Access Compliance Report

Public Rights-of-Way

Intersection ID: N/A	Main Street: MILLENNIUM_AV	Cross Street: POTOMAC_RIVER_PY	Location: SW
ADA ID: 99AED2C51C86	Ramp Type: Directional1	Initial Pass/Fail: Fail	Overall Compliance: No
		Severity Score: 12.5

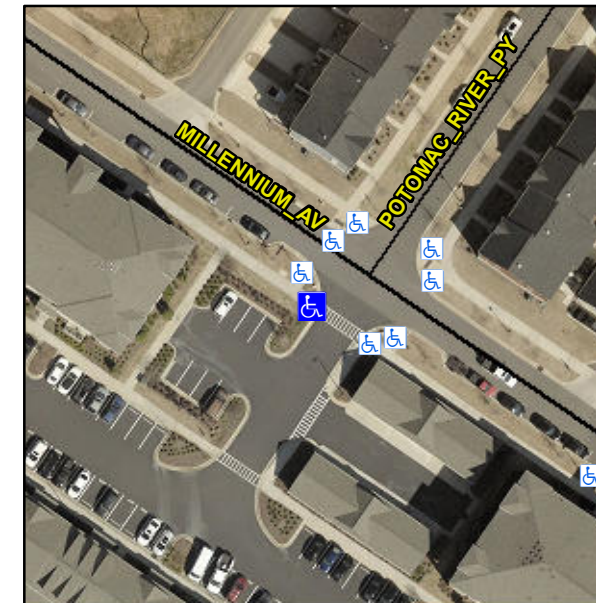
R304.2.2

Compliance	Description	Data	Compliance	Description	Data
N/A	Ramp Length (in)	125.0	N/A	Grade Break?	N/A
Yes	Ramp Width (in)	68.0	N/A	Grade Break Slope (%)	0.0
No	Ramp Slope (%)	10.1	N/A	Grade Break XSlope (%)	0.0
Yes	Ramp XSlope (%)	1.4			
N/A	Flare Type LT	N/A	N/A	Flare Type RT	N/A
N/A	Flare Slope LT (%)	N/A	N/A	Flare Slope RT (%)	0.0
N/A	Flare Traversable LT?	N/A	N/A	Flare Traversable RT?	N/A
N/A	Landing Length (in)	0.0	N/A	DWS Provided?	N/A
N/A	Landing Width (in)	0.0	N/A	DWS Contrast?	N/A
N/A	Landing Slope (%)	0.0	N/A	DWS Length (in)	N/A
N/A	Landing X Slope (%)	0.0	N/A	DWS Full Width?	N/A
N/A	Landing Curb? (Y/N)	N/A	N/A	DWS Offset LT (in)	N/A
N/A	Shared Landing?	N/A	N/A	DWS Offset RT (in)	N/A
N/A	Gutter Ponding?	0.0	N/A	Gutter Slope (%)	N/A
N/A	Gutter Lip Ht (in)	0.0	N/A	Gutter X Slope (%)	N/A
N/A	Painted X Walk1?	Yes		Road Slope (%)	5.4
	X Walk 1 Direction	To SE		Road X Slope (%)	2.2
	X Walk 1 Width (in)	72.0		Clear Space?	N/A

Remove & Replace Entire Ramp.
